Access Compliance Report Public Rights-of-Way (Curb Ramps)

Main Street: HOLT_AVE Cross Street: PLAZA_WY Location: NE

ADA ID: RPRK211011143411 Ramp Type: Type 1 - Perpendicular Diagonal Initial Pass/Fail: Pass Overall Compliance: No Severity Score: 6

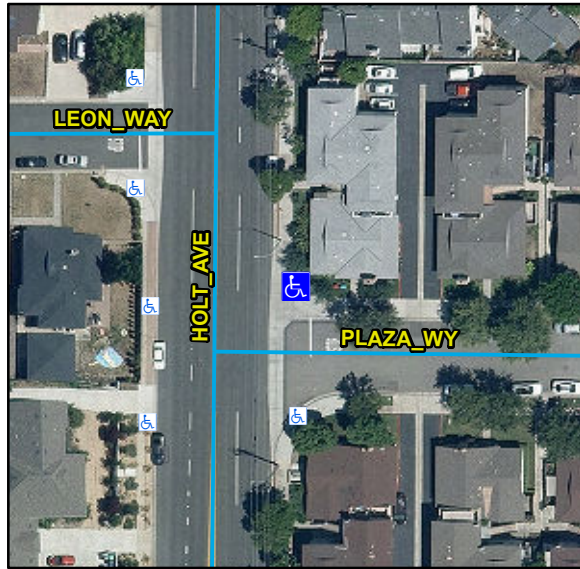
Compliance	Description	Data	Compliance	Description	Data
N/A	Ramp Length (in)	96	N/A	Flare Type LT	
Yes	Ramp Width (in)	60			Sloped
Yes	Ramp Run Slope (%)	7.7	Yes	Flare Slope LT (%)	6.2
Yes	Ramp Cross Slope (%)	0.5	N/A	Flare Traversable LT	Yes
N/A	Landing Present	Yes	N/A	Flare Type RT	
N/A	Landing Length (in)	35			Sloped
Yes	Landing Width (in)	60	Yes	Flare Slope RT (%)	5.2
Yes	Landing Run Slope (%)	0.9	N/A	Flare Traversable RT	Yes
Yes	Landing Cross Slope (%)	0.8	Yes	DWS Provided	Yes
N/A	Landing Movement Obstructed?	Yes	Yes	DWS Contrast	Yes
	Landing Movement Type	Curb	Yes	DWS Length (in)	36
N/A	Landing Shared	No	Yes	DWS Full Width	Yes
N/A	Clear Space	Yes	Yes	DWS Offset Left (in)	0
N/A	Clear Space To Crosswalk (in)	48	Yes	DWS Offset Right (in)	N/A
N/A	Marked Crosswalk 1	No	N/A	Marked Crosswalk 2	No
	Crossing 1 Direction	W		Crossing 2 Direction	S
	Marked Crosswalk 1 Width (in)	N/A		Marked Crosswalk 2 Width (in)	N/A

Remove & Replace Landing.
